City of Portland Design Commission

Design Advice Request

SUMMARY MEMO

Date: July 25, 2019
To: David Howard, Mark Coplin, Jason Erdahl | Ankrom Moisan Architects
From: Tanya Paglia, Design Review
503-823-4989 | tanya.paglia@portlandoregon.gov
Re: EA 19-134120 DAR – 3100/3150 NE Sandy Blvd | MorningStar at Laurelhurst
Design Advice Request Commission Summary Memo – July 11, 2019

CONCEPTUAL FLOOR PLAN - SANDY BLVD - DAR #2
AFTER

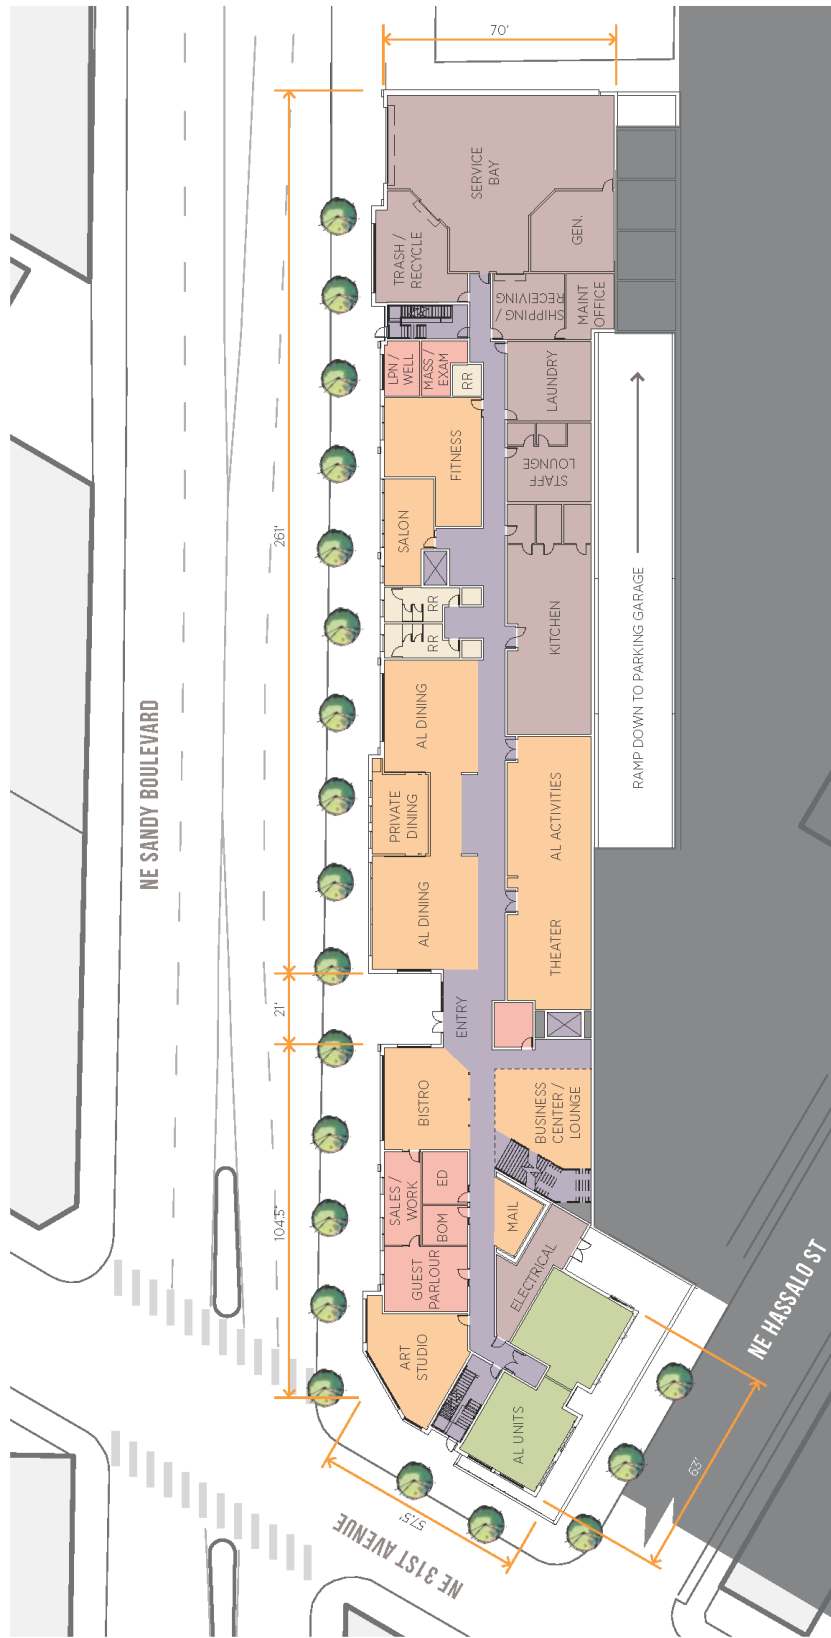
- The notch carried up the whole building and the Sandy entrance relocated into the notch are huge improvements from DAR #1. Having the main entrance in the notch makes it more meaningful and the design of the Sandy entry is moving in the right direction, especially the programming change of having a coffeehouse/bistro space next to the entry.

- The entry court is a big, deep space that could be an outdoor room on Sandy and could be better utilized. It still reads somewhat like a back door.
- The design as presented looks like a bland, dark, inactive space. The heavy canopy also makes it feel compressed. The applicant should explore ways to create a more pleasant path into the building, bring more life to the exterior of the building at the notch and allow more light into the space. This could include:

- Including more glass at the ground as well as the upper floors around the notch. The opaque sidewalls of the notch as it carries up the building are huge missed opportunities for views out and activation of the façade. Placing amenity spaces around

- Centering the door to make it feel more like a front door and less like an office.
- While the programming on either side of the entry is not commercial space, it is active space and it should be made clear on the exterior of the building that these uses are “retail-like”.
